产品问题反馈 Product Feedback

»» 项目编号-Project NO. : UN20177

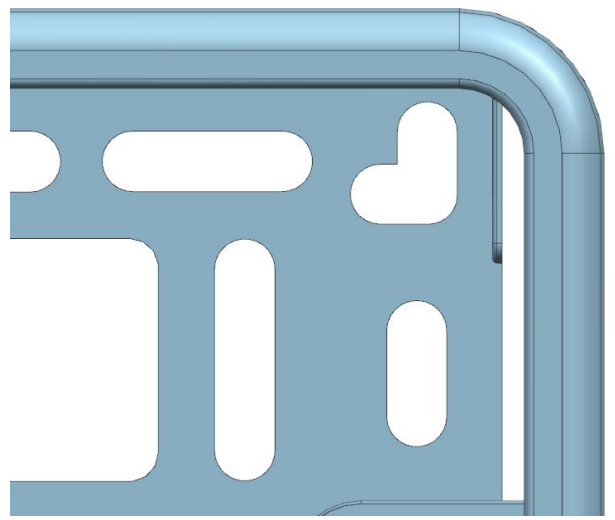
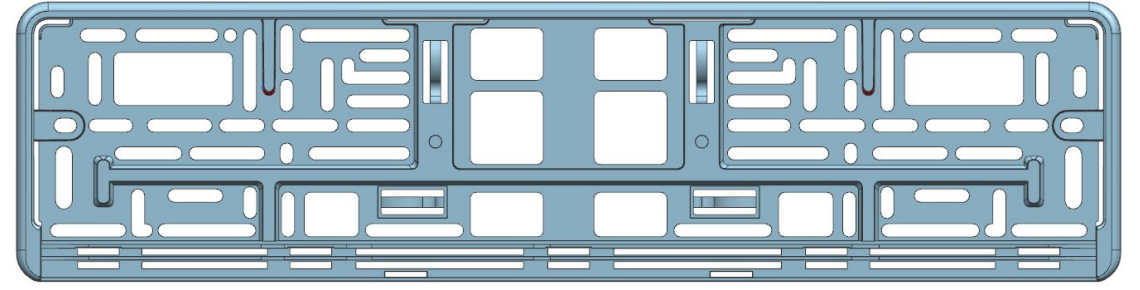
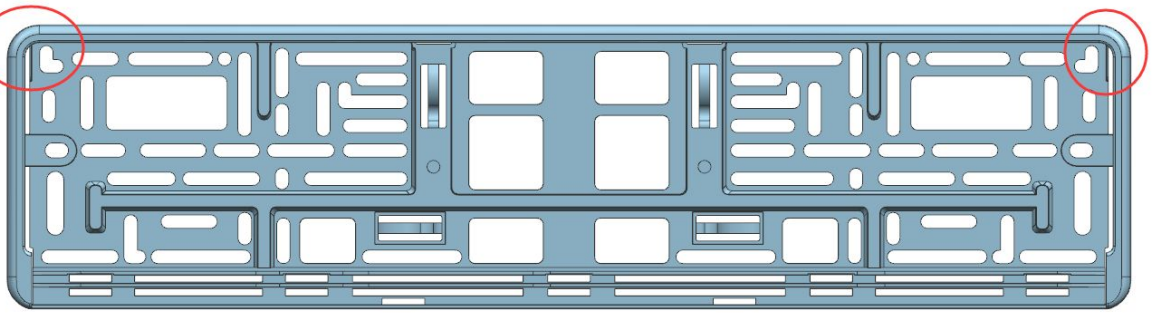
如图, 孔每边加大15mm
Can we make Hole length longer by 15mm on both sides ?

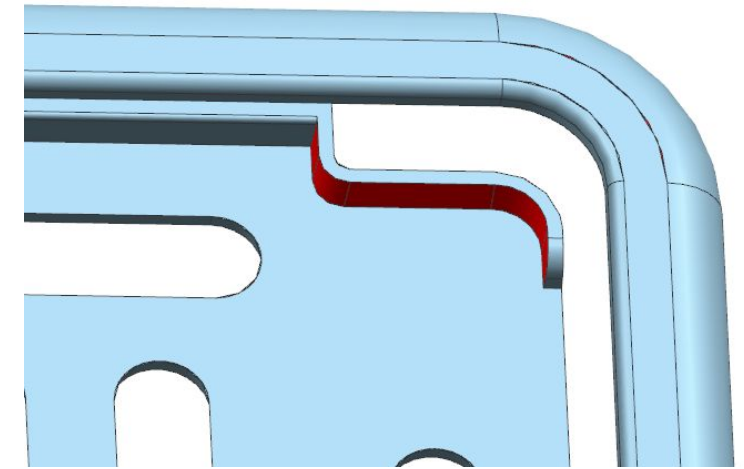
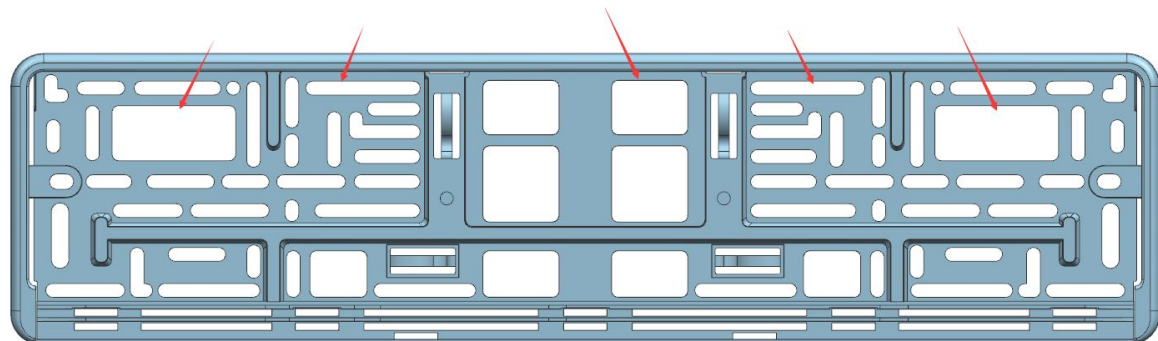
如图, 筋位改变
Can we make change on rib design

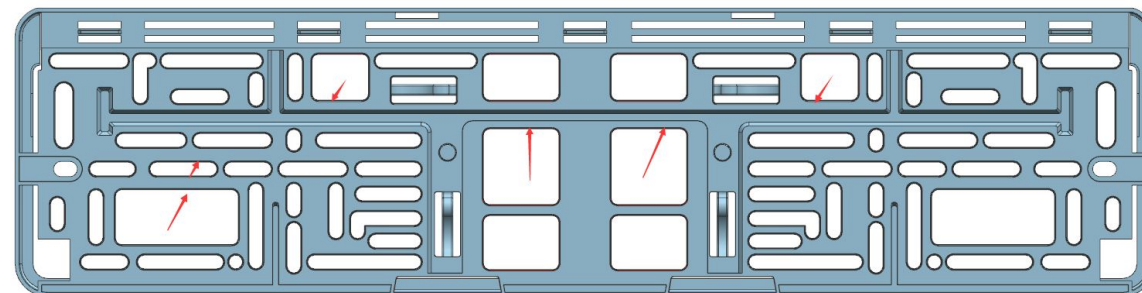
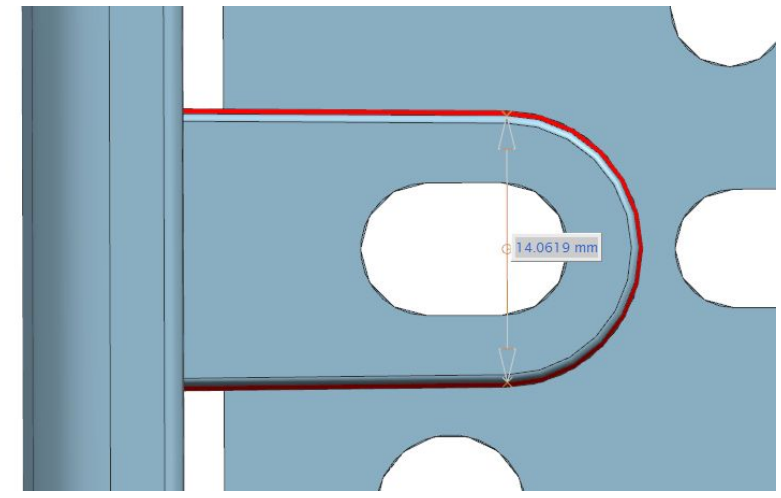
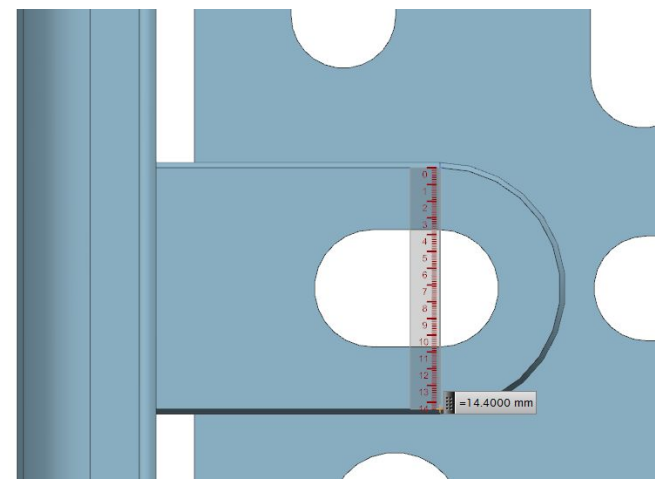
如图, 类似的孔, 斜度加大到10度
Can we make hole angle to 10 degree

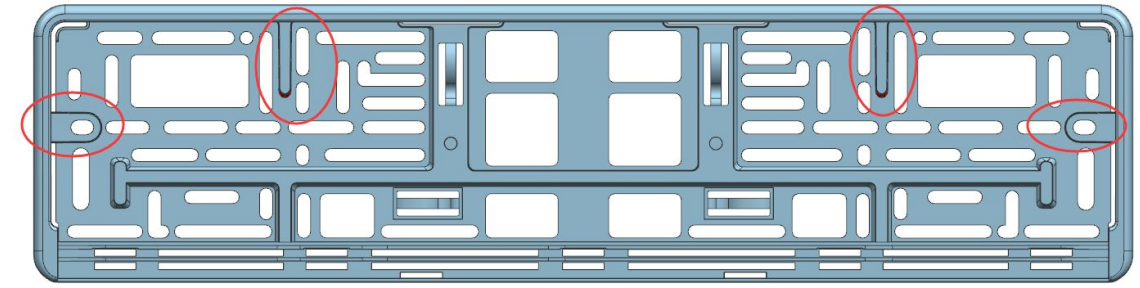
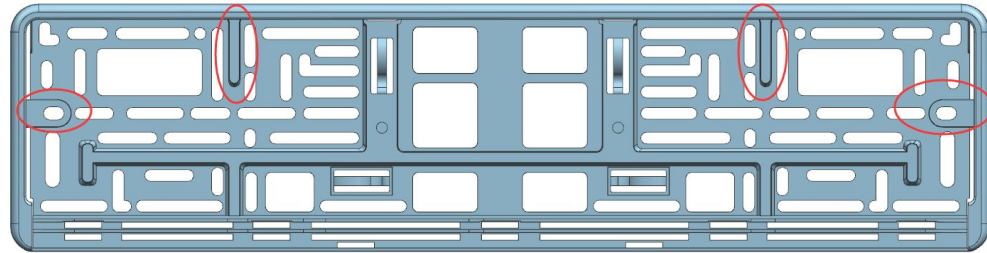
如图4个形状头部缩小单边0.2mm方便脱模
Can we reduce by 0.2mm on every side, it will be easier for mold ejection

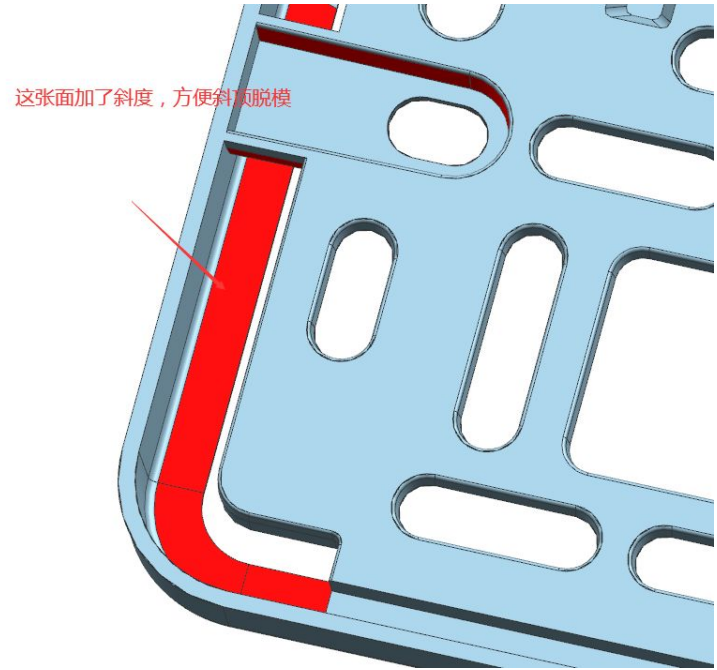
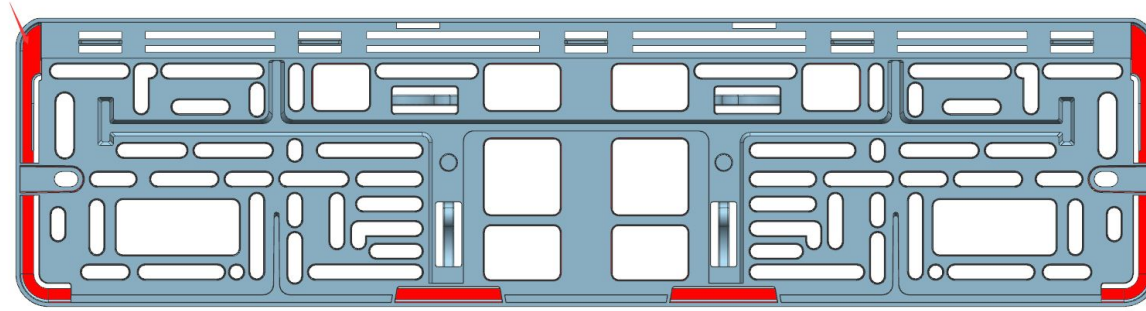
这张面加了斜度, 方便斜顶脱模

From UNION (Author: Erik)	From	Ok/Not	Reply time
Can we add angle on lifter, it will be easier for mold ejection
